# **ENVIRONMENTAL IMPACT REPORT ADDENDUM**

**FAIRFIELD TRAIN STATION SPECIFIC PLAN  
CITY OF FAIRFIELD, CALIFORNIA**

**STATE CLEARINGHOUSE NO. 2010042093**

February 2023

Fairfield Train Station Specific Plan EIR Addendum  
Habitat (As Mapped in the 2010 FTSSP EIR)

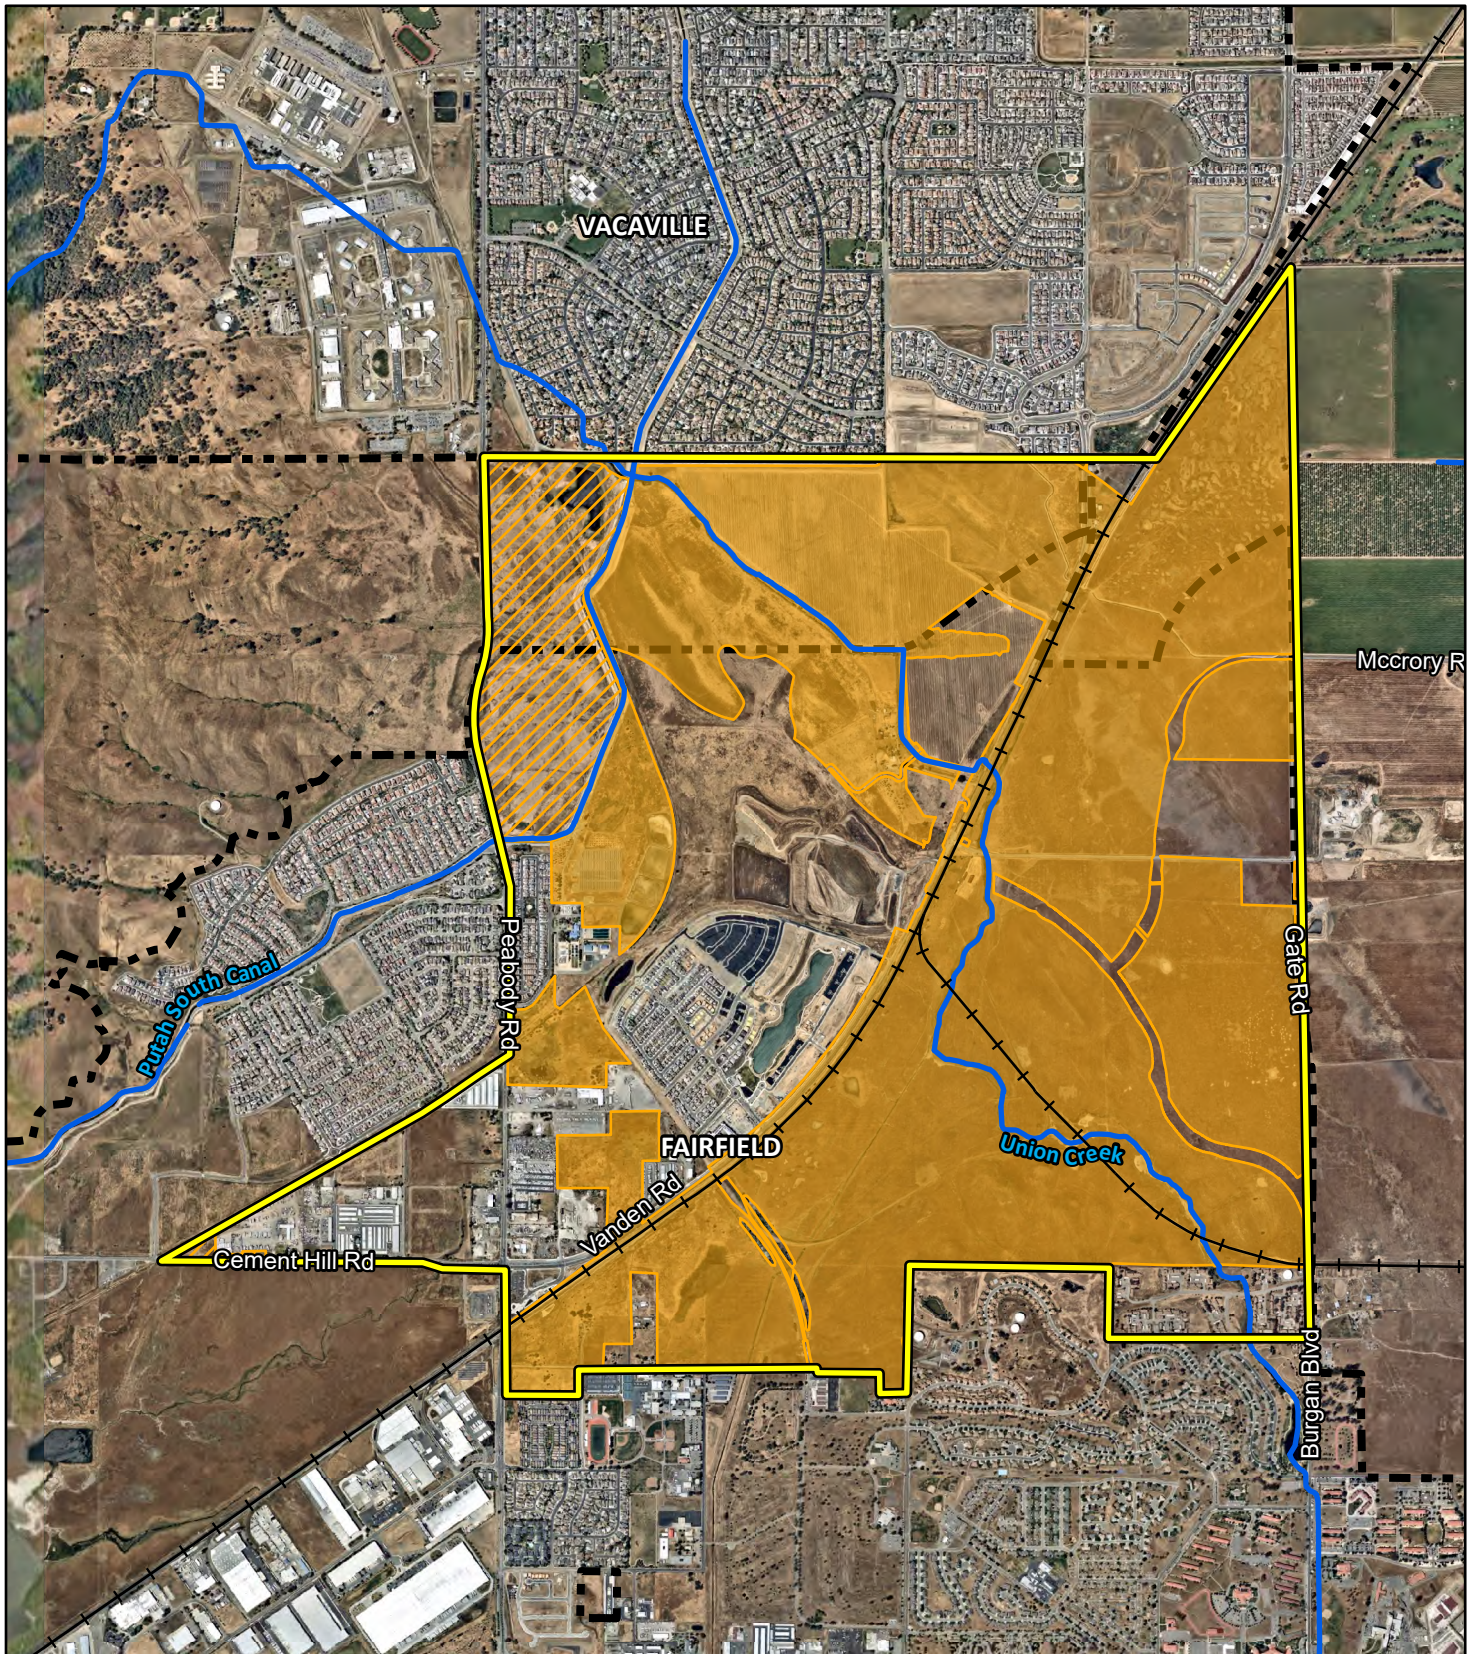
Mitigation Measure 4.4-2c addresses the impacts on Swainson’s hawk (*Buteo swainsoni*) and other raptors, including burrowing owl (*Athene cunicularia*), resulting from the implementation of the FTSSP and describes requirements for preconstruction surveys for active nests or burrows, avoidance measures, and the required compensatory mitigation ratios for direct impacts to nests and the conversion of Swainson’s hawk and burrowing owl habitat consistent with the Draft Solano HCP. Minor revisions to Mitigation Measure 4.4-2c are proposed to distinguish between the Solano HCP compensatory mitigation requirements for Swainson’s hawk and burrowing owl based on the habitat type impacted. The mitigation measure, as currently worded, only addresses the compensatory mitigation requirements for impacts to valley floor grassland habitat and does not distinguish between the mitigation requirements for valley floor grassland and agricultural habitat types shown in Exhibit 4.4-1 from the FTSSP EIR (Figure 3).

Mitigation Measure 4.4-2c is thus modified as follows for consistency with the Draft Solano HCP to clarify the compensatory mitigation habitat requirements based on habitat type:

- 3) *To mitigate impacts on Swainson's hawk foraging habitat consistent with the SMHCP, implement Mitigation Measure 4.4-2a, which requires that 3 acres of valley floor grassland habitat be preserved for every 1 acre lost to development. This mitigation can be concurrent with mitigation for California tiger salamander habitat provided the valley floor grassland habitat preserved is suitable for both species. Projects located outside the Specific Plan Area grasslands that provide California tiger salamander habitat shall preserve suitable habitat at a minimum 1:1 ratio, or as determined by the final adopted SMHCP. ~~and retain Active and suitable nest trees within and adjacent to foraging habitat shall be retained to the maximum extent practicable. This mitigation can be concurrent with mitigation for California tiger salamander habitat provided the valley floor grassland habitat preserved is suitable for both species.~~*

- 7) *Project applicants shall mitigate for the permanent loss or conversion of burrowing owl habitat within Specific Plan Area grasslands that provide California tiger salamander habitat, valley floor or vernal pool grassland, grain and hay crops, pasture, irrigated agriculture, fallow fields by preserving suitable habitat at a 3:1 ratio. Implementing Mitigation Measure 4.4-2a, which requires that 3 acres of valley floor grassland habitat be preserved for every 1 acre lost to development, would provide adequate mitigation for loss of burrowing owl habitat. Projects located outside the Specific Plan Area grasslands that provide California tiger salamander habitat shall preserve suitable habitat at a minimum 1:1 ratio, or as determined by the final adopted SMHCP. As discussed previously, the Specific Plan Area is identified in the SMHCP as being within the Valley Floor Grassland Conservation Area.*
